World Forum for Harmonization of Vehicle Regulations**Working Party on Passive Safety****Seventieth session**

Geneva, 6–10 December 2021

Item 12 of the provisional agenda

UN Regulation No. 135 (Pole Side Impact (PSI))**Proposal for the 02 series of amendments to UN
Regulation No. 135 (Pole Side Impact (PSI))****Submitted by the expert from the Netherlands ***

“Annex 2

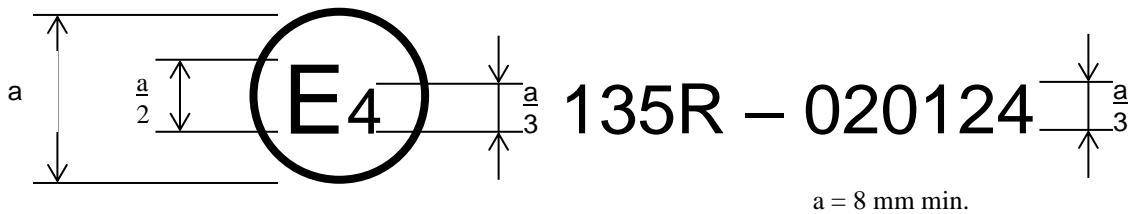
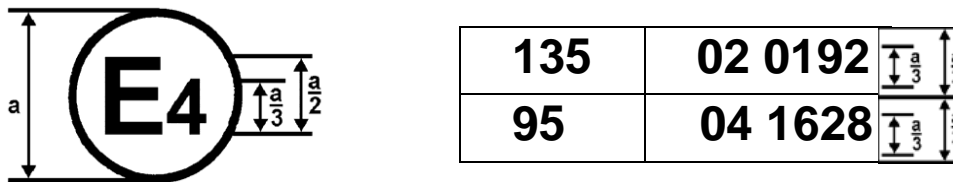
Annex 2, amend to read:

The above approval mark affixed to a vehicle shows that the vehicle type concerned has, with regard to its pole side impact performance, been approved in the Netherlands (E 4) pursuant to Regulation No. 135 under approval number **0124**. The approval number indicates that the approval was granted in accordance with the requirements of Regulation No. 135 as amended by the **02** series of amendments.

The above approval mark affixed to a vehicle shows that the vehicle type concerned has been approved in the Netherlands (E 4) pursuant to Regulations Nos. 135 and 95.¹ The first two digits of the approval numbers indicate that, at the dates when the respective approvals were granted, Regulation No. 135 incorporated the **02** series of amendments and Regulation No. 95 incorporated the **04** series of amendments.”
